DEPARTMENT OF THE AIR FORCE
AIR FORCE CIVIL ENGINEER CENTER

October 25, 2019

Cannon Air Force Base (AFB) initiated field work in support of the approved work plan at DP034; "Approval with modifications RCRA Facility Investigation (RFI) work plan at DP034 Revision 1", dated July 3, 2019. The geophysical survey was crucial in determining the area of the debris pit. The geophysical survey revealed the debris pit to be larger than 15 feet by 15 feet by 5 feet deep (GPR and EMI results attached for reference).

Attachment: GPR-EMI results and proposed boring locations

Figure 2
Geophysical Survey Results
Historical Debris Pit DP034

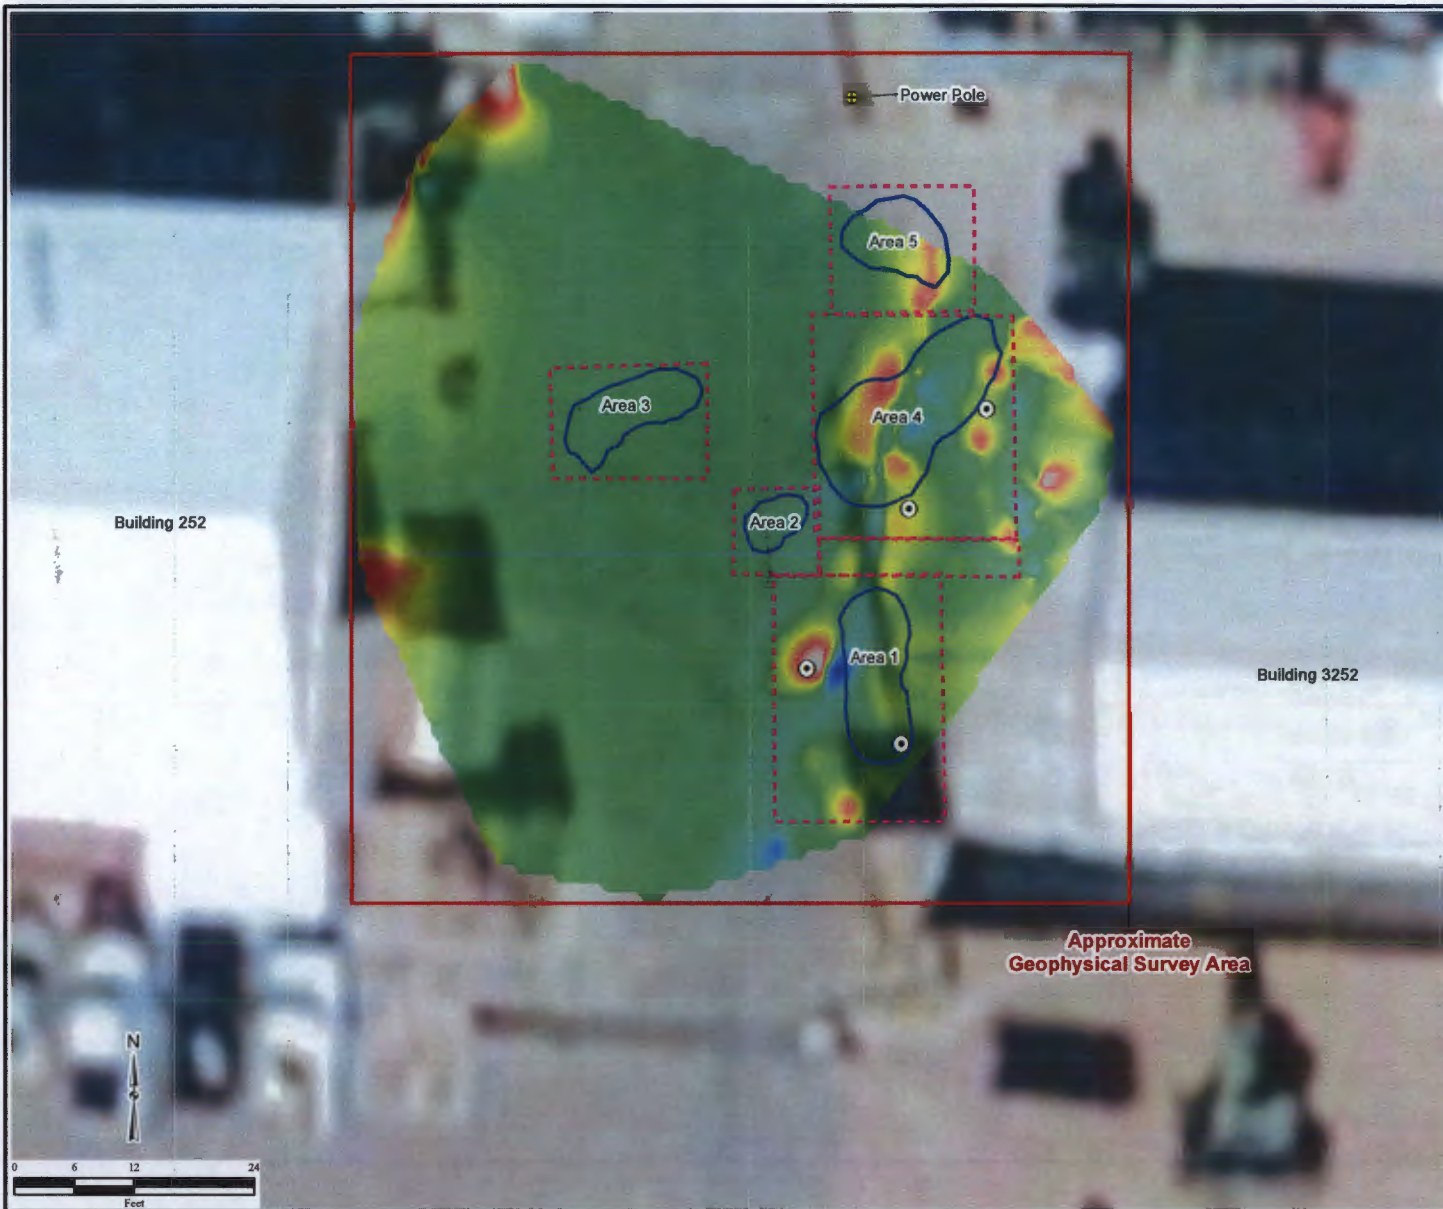
Pink square = possible SB location
